Reference: Notice of Change #MAG910790

3 Arlington Street Quincy, MA

On behalf of Walsh Contracting Corp. (Walsh), Lockwood Remediation Technologies, LLC (LRT) has prepared this Notice of Change (NOC) for NPDES Permit # MAG910790 in accordance with the general requirements of the NPDES and related guidance documentation provided by EPA. The completed NOC form is attached.

Figure 2 - Discharge Location 3 Arlington Street

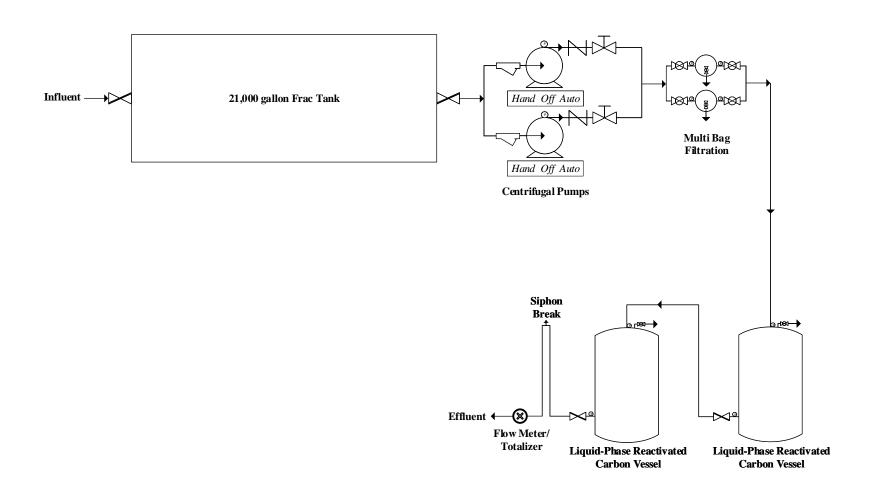
On May 7, 2018, the EPA issued a NPDES RGP to discharge treated water to the Neponset River that will be generated during dewatering activities for the above-referenced site. Due to an increase in the amount of water generated during excavation and dewatering activities, LRT on behalf of Walsh is requesting that the discharge flow rate be increased from 300 gallons per minute (gpm) to 500 gpm. The increase in the flow rate: 1) will not exceed 1.0 million gallons per day (mgd). The increase in flow rate indicates a flow of 0.720 mgd; 2) will not exceed the design flow of the treatment system; 3) has not changed any water quality based effluent limitations (WQBEL); and 4) the effluent limitations will continue to be complied. See attached for revised figure with 500 gpm system layout and WQBEL calculations. In addition, the discharge location changed from a catch basin in Arlington Street to a catch basin in Fayette Street. See attached figure for discharge location.
